Access Compliance Report

Public Rights-of-Way

(Curb Ramps)

Intersection ID: 50998	Main Street: S_TRYON_ST	Cross Street: STEELECROFT_PY	Location: NW
ADA ID: 7FD9951AB4BF	Ramp Type: Perp	Initial Pass/Fail: Fail	Overall Compliance: No
Severity Score: 12.5			
Codes/Mitigation Info/Possible Solution		Field Measurements/Component Compliance

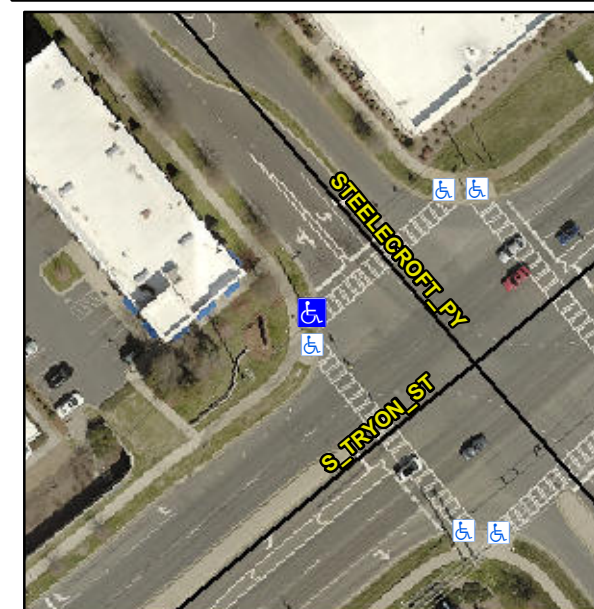
Not Found, R304.2.2

Compliance	Description	Data	Compliance	Description	Data
N/A	Ramp Length (in)	100.0	No	Ramp Slope (%)	10.1
Yes	Ramp Width (in)	48.0	Yes	Ramp XSlope (%)	0.4
N/A	Flare Type LT	N/A	N/A	Flare Type RT	N/A
N/A	Flare Slope LT (%)	N/A	N/A	Flare Slope RT (%)	N/A
N/A	Flare Traversable LT?	N/A	N/A	Flare Traversable RT?	N/A
N/A	Landing Length (in)	N/A	N/A	DWS Provided?	N/A
N/A	Landing Width (in)	N/A	N/A	DWS Contrast?	N/A
N/A	Landing Slope (%)	N/A	N/A	DWS Length (in)	N/A
N/A	Landing X Slope (%)	N/A	N/A	DWS Full Width?	N/A
N/A	Landing Curb? (Y/N)	N/A	N/A	DWS Offset (in)	N/A
N/A	Shared Landing?	N/A			
N/A	Gutter Ponding?	N/A	N/A	Gutter Slope (%)	N/A
N/A	Gutter Lip Ht (in)	N/A	N/A	Gutter X Slope (%)	N/A
N/A	Painted X Walk1?	Yes	N/A	Painted X Walk2?	N/A
	X Walk 1 Direction	To NE		X Walk 2 Direction	N/A
N/A	X Walk 1 Width (in)	111.0	N/A	X Walk 2 Width (in)	N/A
	X Walk 1 Slope (%)	2.6		X Walk 2 Slope (%)	N/A
	X Walk 1 X Slope (%)	3.8		X Walk 2 X Slope (%)	N/A

Remove & Replace Entire Ramp.
